SERVICE LETTER

No. 539

Subject: Fuel Selector Valve Control Handle Replacement

Models Affected: PA-30 Twin Comanche

Serial Numbers 30-1 to 30-826 inclusive

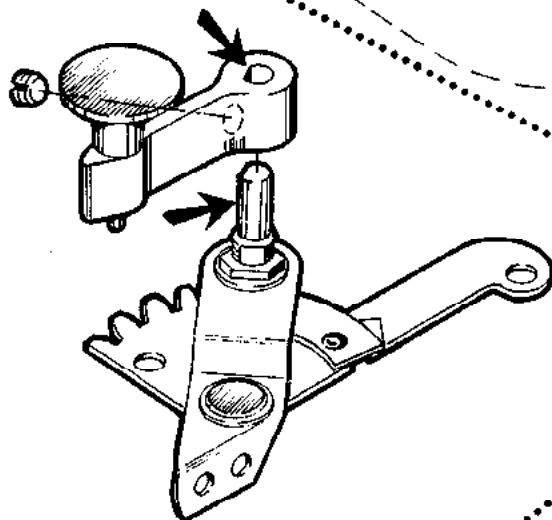
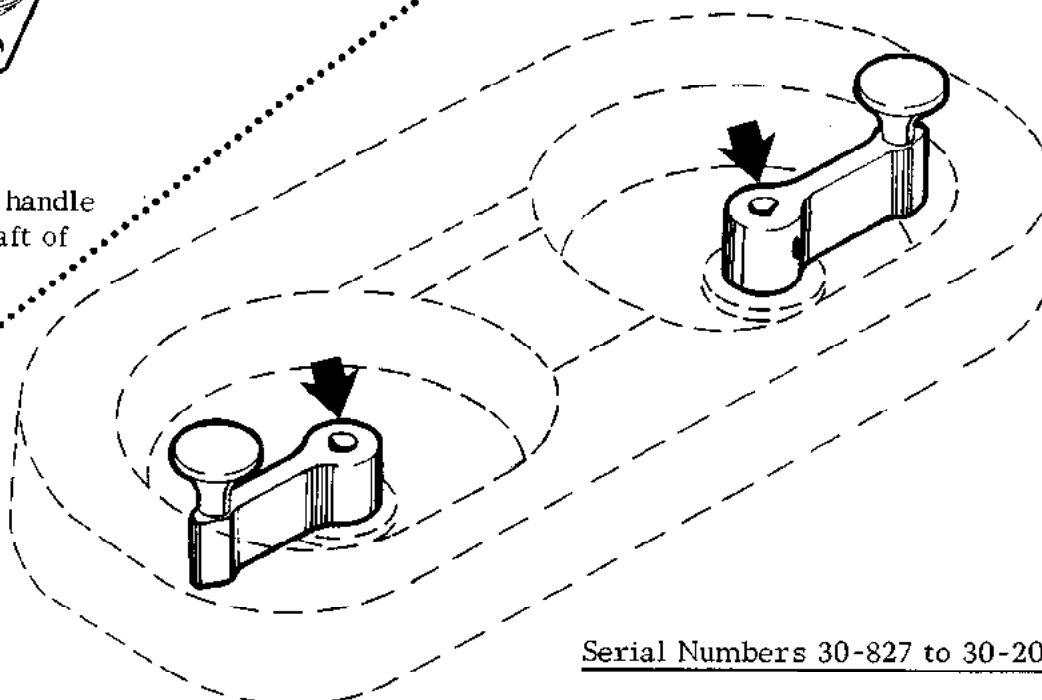
Purpose: To provide fuel selector valve control handles with a positive alignment to the fuel selector control valve shaft (please refer to sketch attached to this letter for general information).

"D" shaped hole in handle
to match flat on shaft of
control assembly.

Instructions: Contained in Fuel Selector Valve Control Handle Replacement Kits, part numbers 760 356 or 760 357 (see Material Required, below).

Material Required: PA-30, Serial Nos. 30-1 to 30-826 incl.; Fuel Selector Valve Control Handle Replacement Kit No. 760 356.
PA-30, Serial Nos. 30-827 to 30-2000 incl.; Fuel Selector Valve Control Handle Replacement Kit No. 760 357.

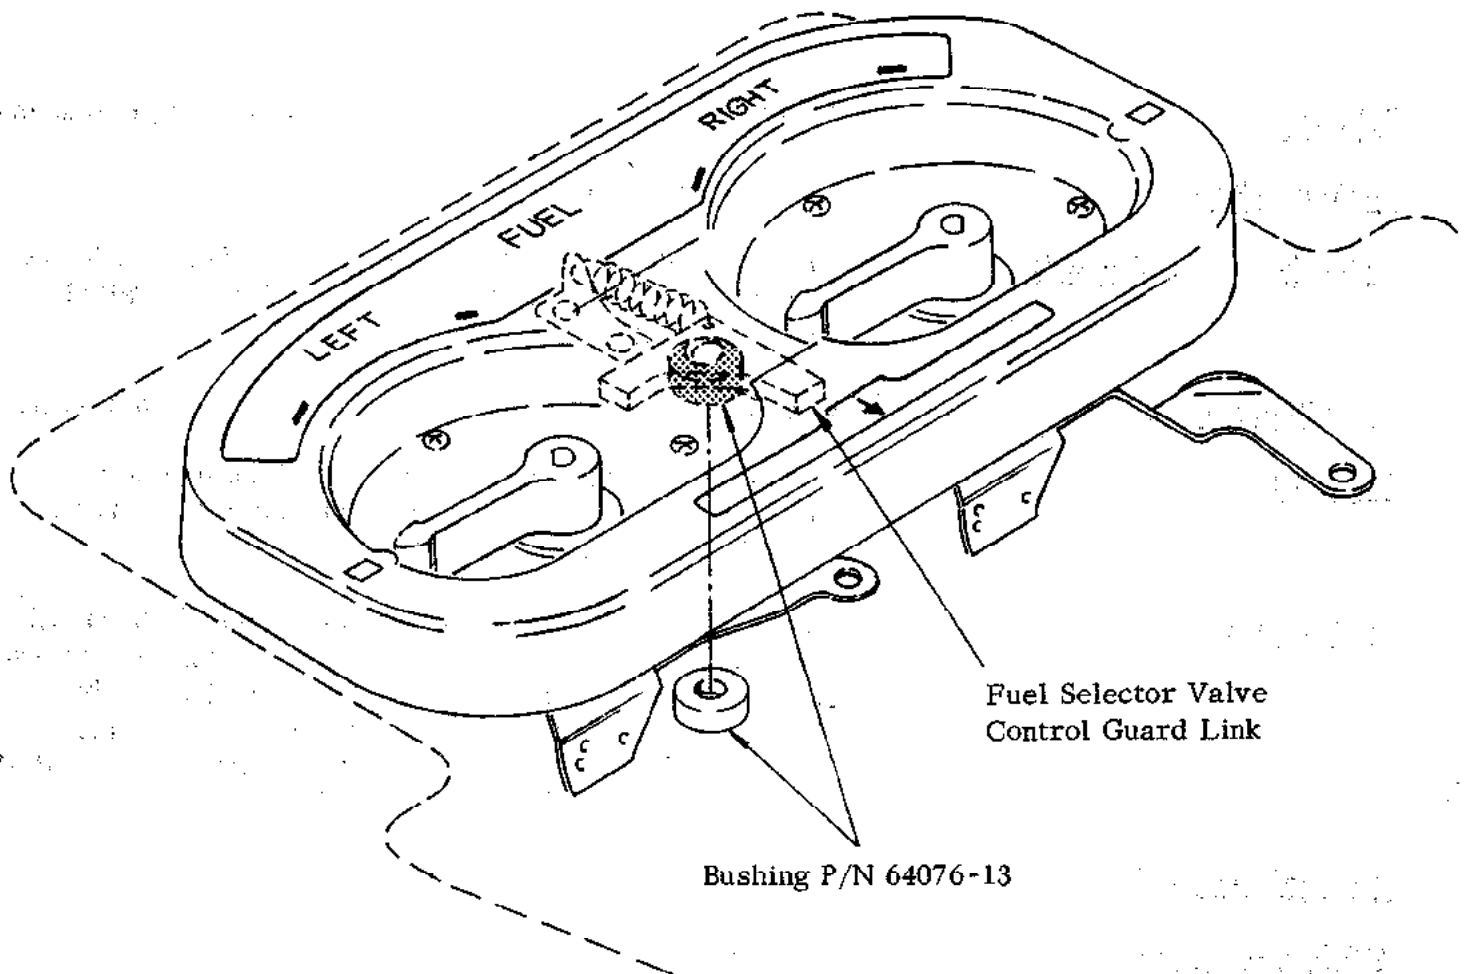
Purpose: To insure a more positive alignment of the fuel selector valve control handle and the fuel selector valve control guard link (part number 24149-00).

Instructions: Install one (1) each fuel selector valve control guard link bushing part number 64076-13 per the sketch/instructions contained on the reverse side of this addendum on the above referenced PA-30 aircraft which have had Fuel Selector Valve Control Handle Replacement Kit No. 760 356 installed per Piper Service Letter No. 539.

Remove fuel selector valve control handles and fuel selector valve protector plate. Remove the fuel selector valve control guard link and the bushing which is located underneath the link. Reinstall the guard link using the new bushing P/N 64076-13. Reinstall the fuel selector valve protector plate and check for sufficient clearance between the guard link and protector plate. If necessary, rework protector plate to remove any interference. Reinstall the fuel selector valve handles.

It will be necessary to replace the self-locking set screw with a new set screw (Part No. 419 964) each time the handle is disassembled from the shaft.

Ascertain that the handles are seated securely down against the shoulder of the control shaft. Tighten set screw securely against the flat portion of the control assembly shaft to ensure tight attachment.
